CITY OF ST. CHARLES ILLINOIS • 1834	**AGENDA ITEM EXECUTIVE SUMMARY**	**Agenda Item Number: *4f**
	Title:	Recommendation to approve a Minor Change to PUD for Meijer Outlot, Building A.
	Presenter:	Ellen Johnson

MINOR CHANGE TO PUD APPLICATION

Memo

Subject: Minor Change to PUD
Meijer Outlot PUD Ordinance 2018-Z-9

Building A – Proposed Chipotle

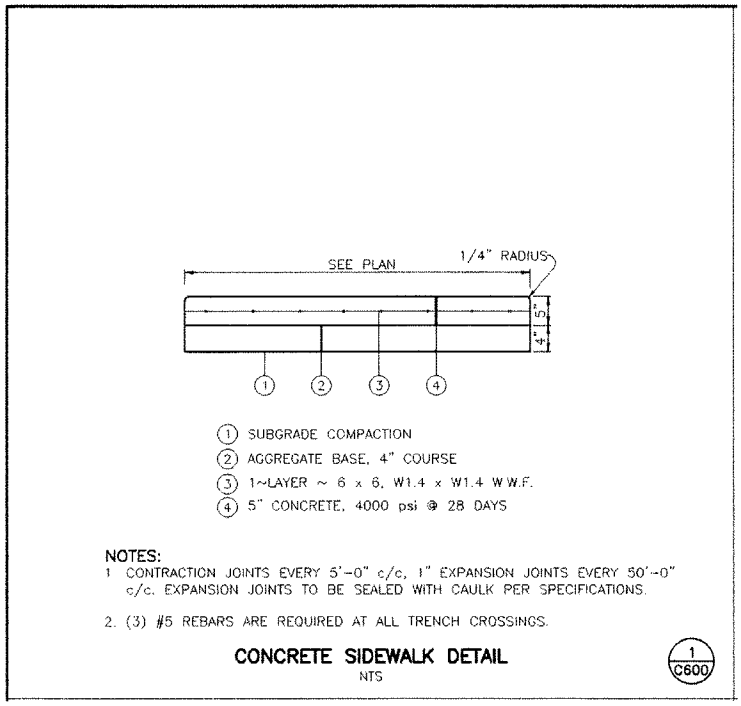
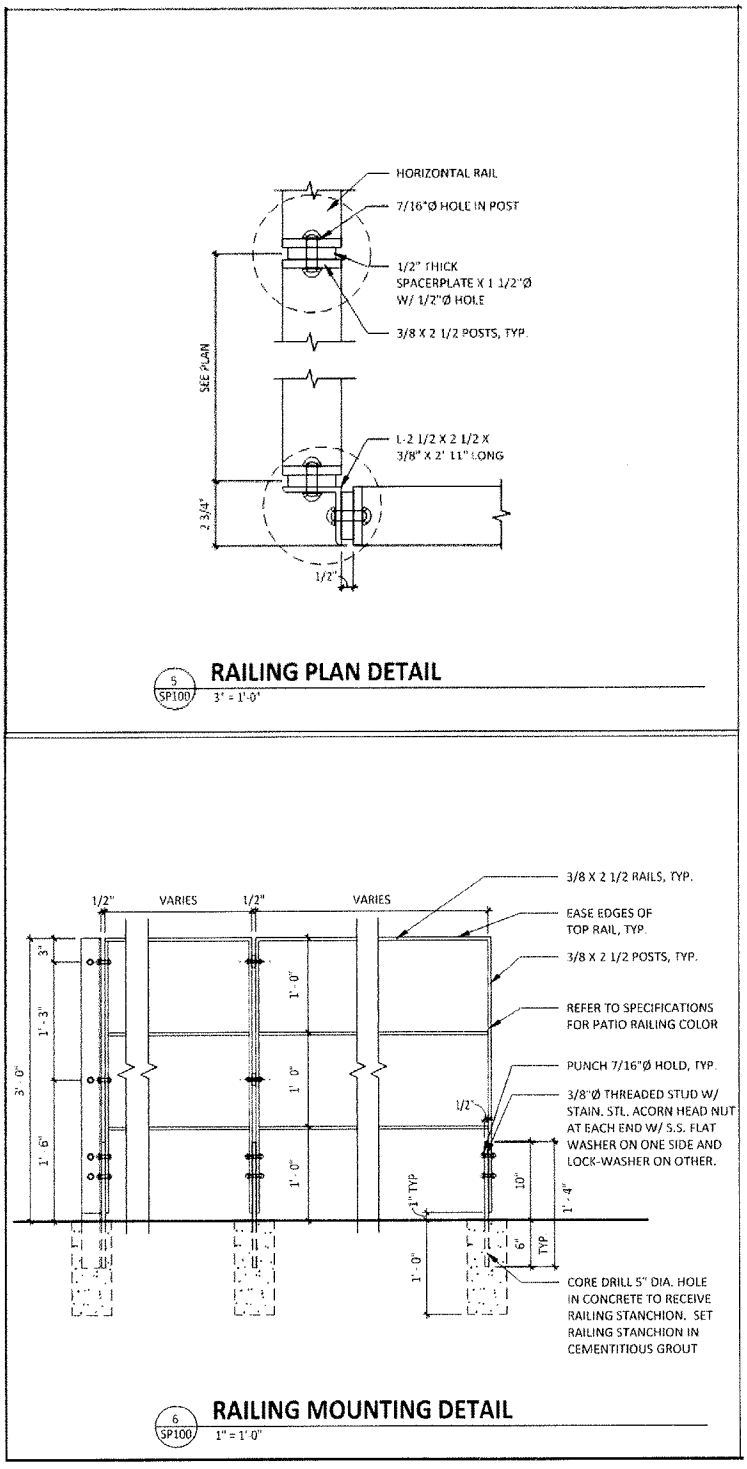
- Wider drive-thru by-pass lane with 5 angled parking spaces
- Additional concrete ramp access from parking lot
- Addition of 350 sf concrete patio matching sidewalk thickness with protective railing. See the following details:

SHEET NO.
C200

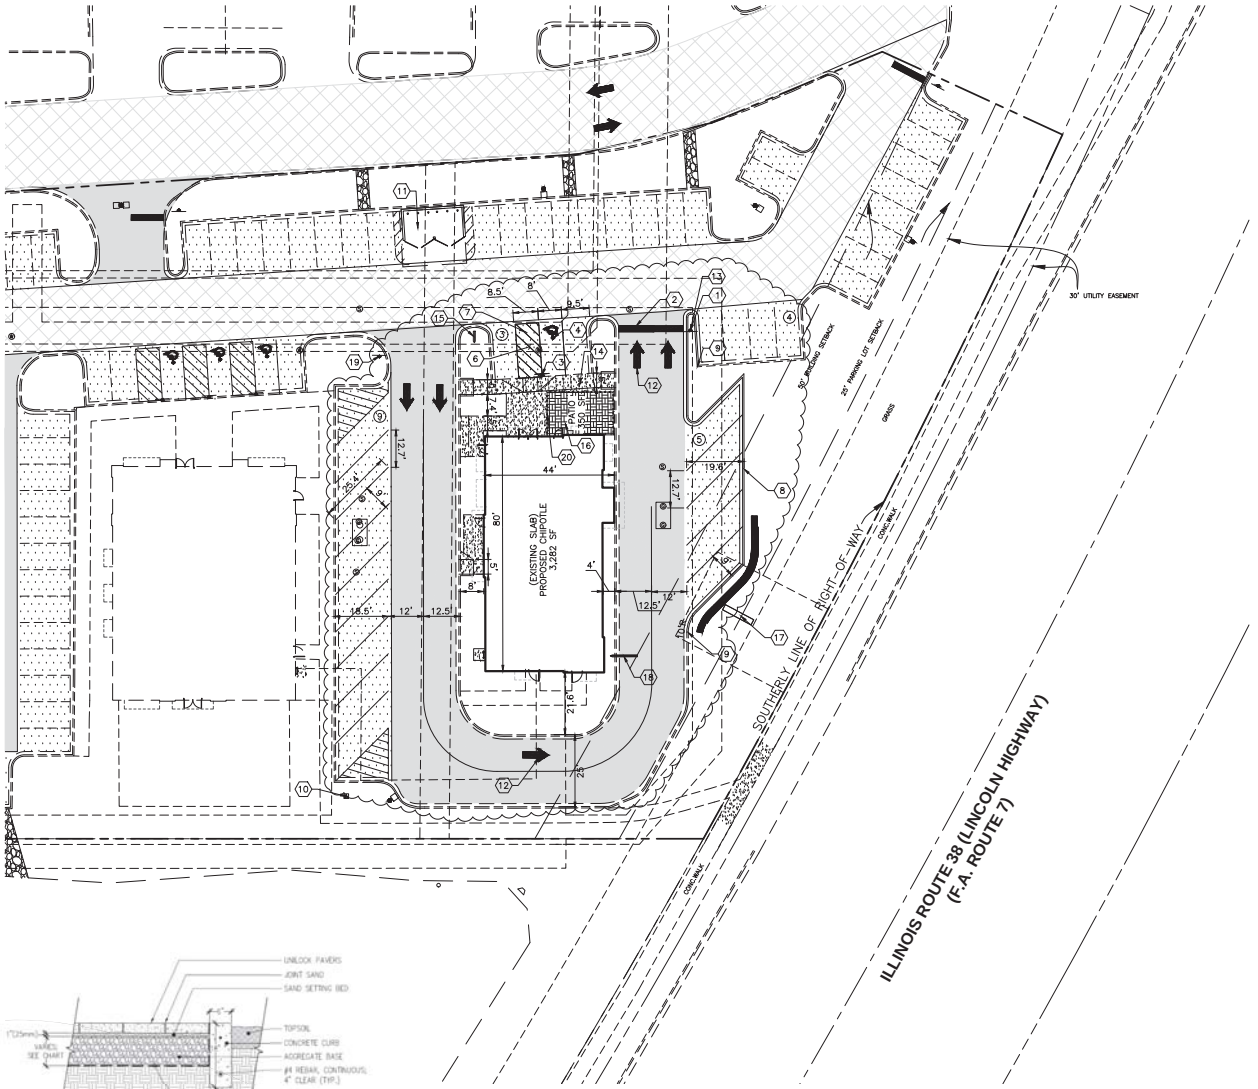
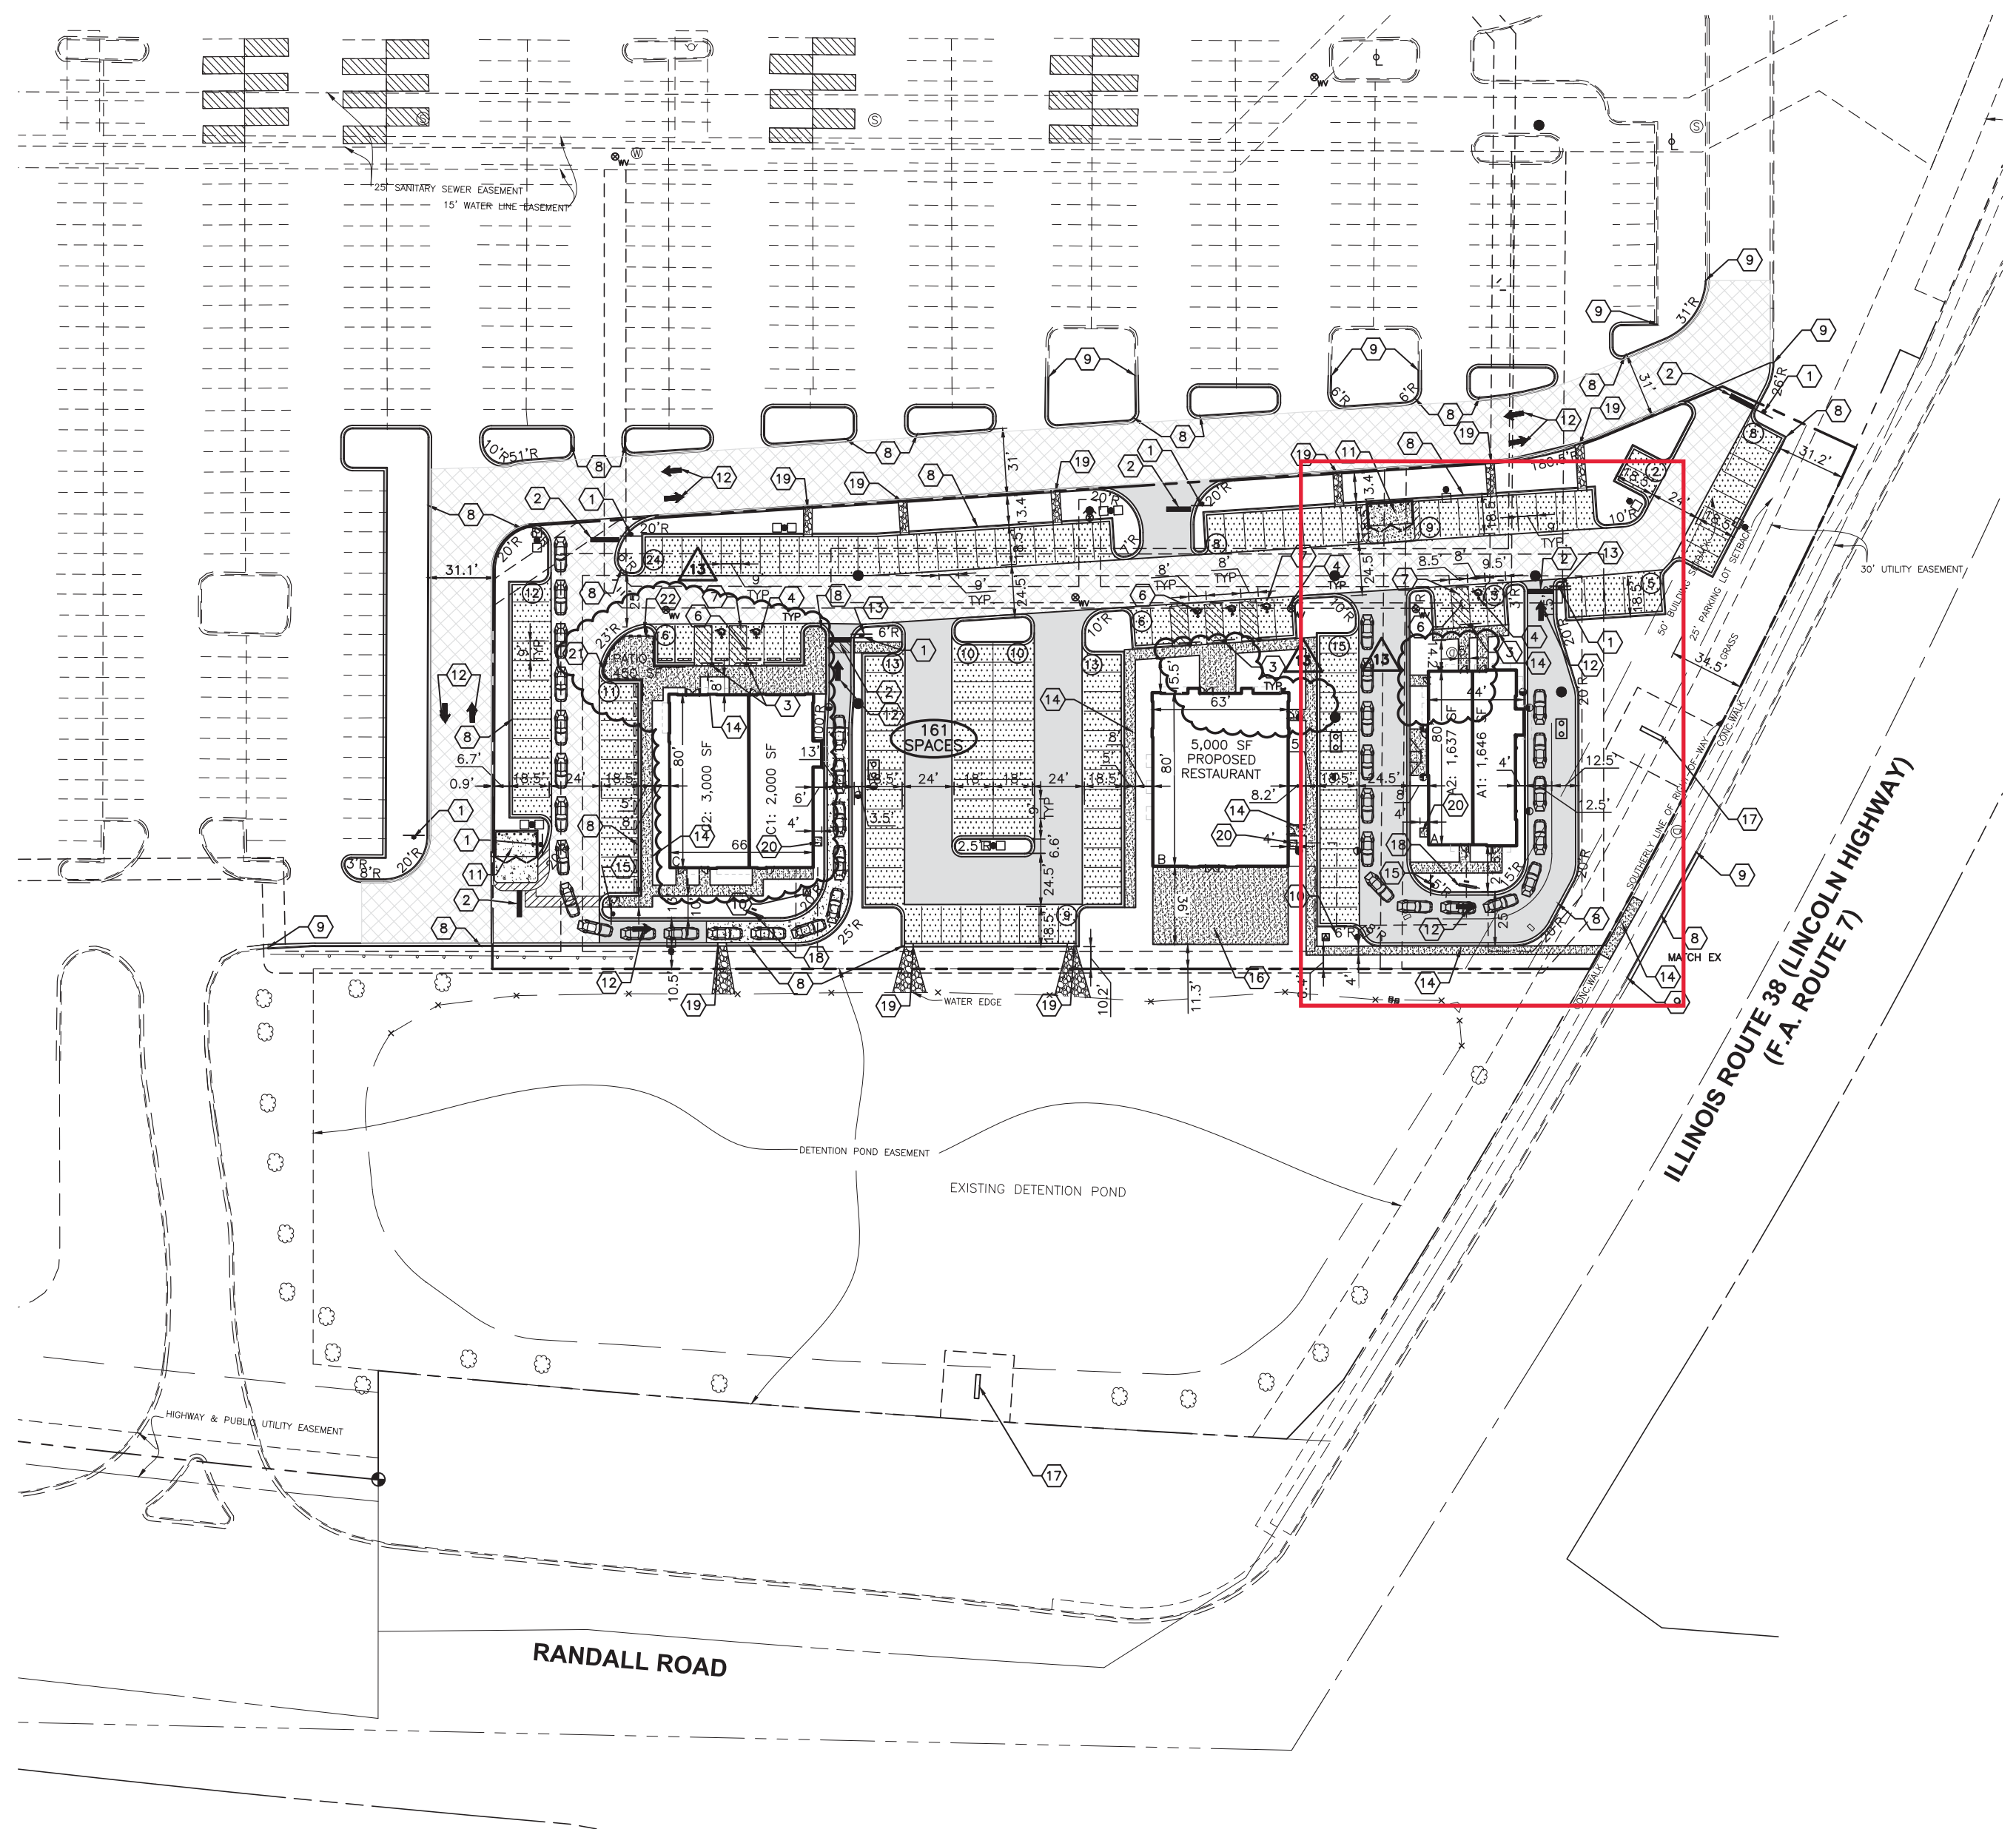
- Add 5 parking stalls on the north side of the drive-through lane with a retaining wall.
- Extend the drive-through bypass lane along the north side of the drive-through.
- Convert the driveway on the west side of the building to one-way with angled parking stalls.
- Eliminate 1 parking stall at the northwest corner of the building.
- Add a 350 sf paver patio at the west side of the building near the entrance.
- Modify foundation landscaping to accommodate the patio.

These revisions are reflected on the attached Site Plan, Grading Plan, SRW Details, and Landscape Plan. All revisions are clouded.

SHEET NO.
C300

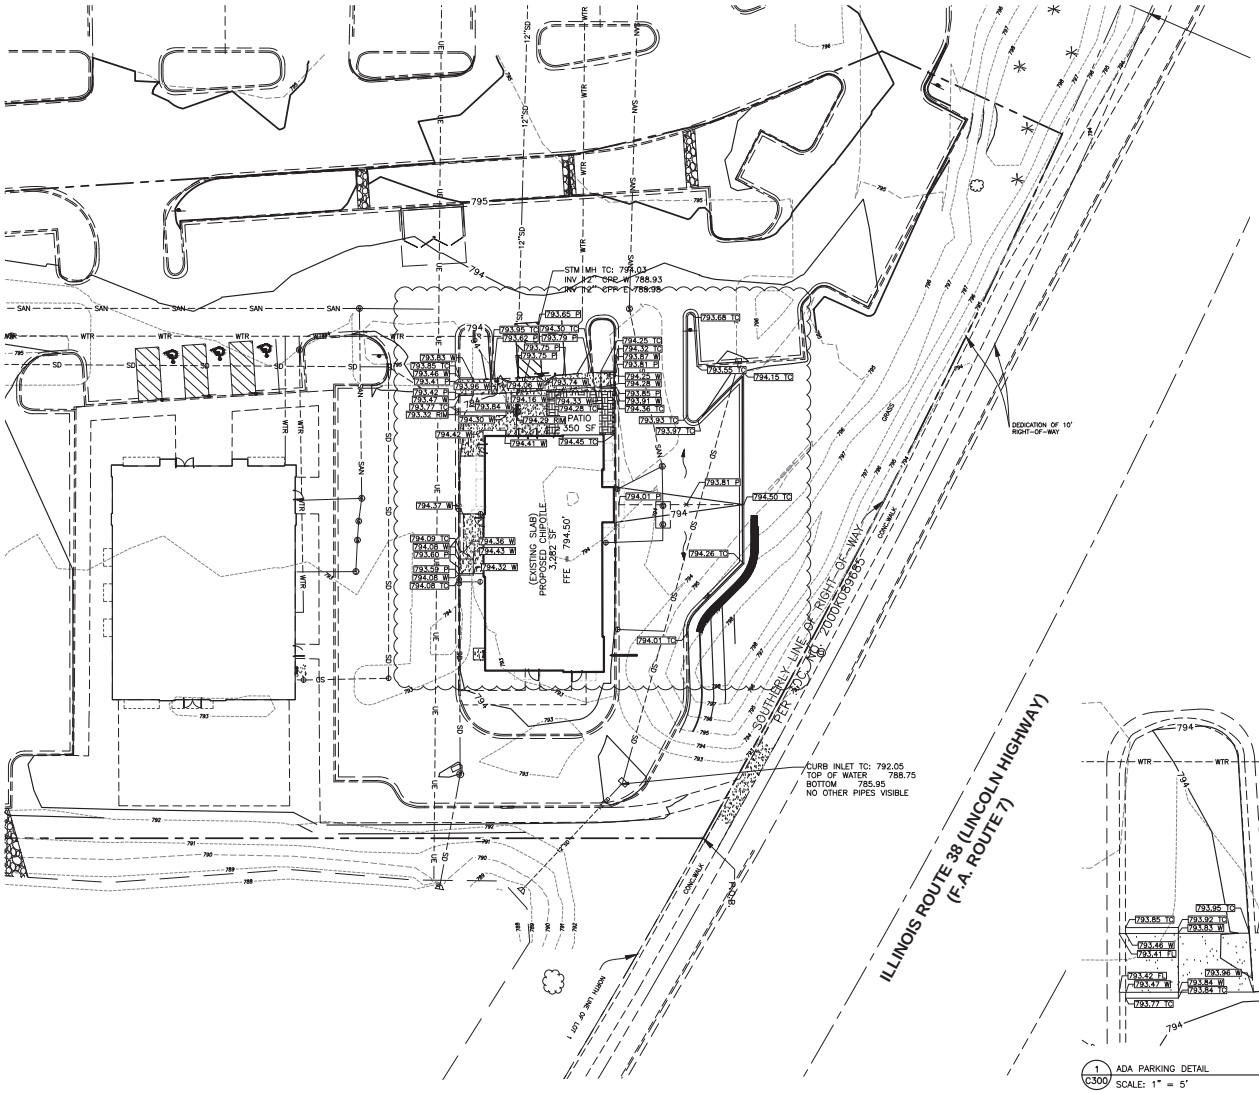
Proposed additional parking and retaining wall North of Building A
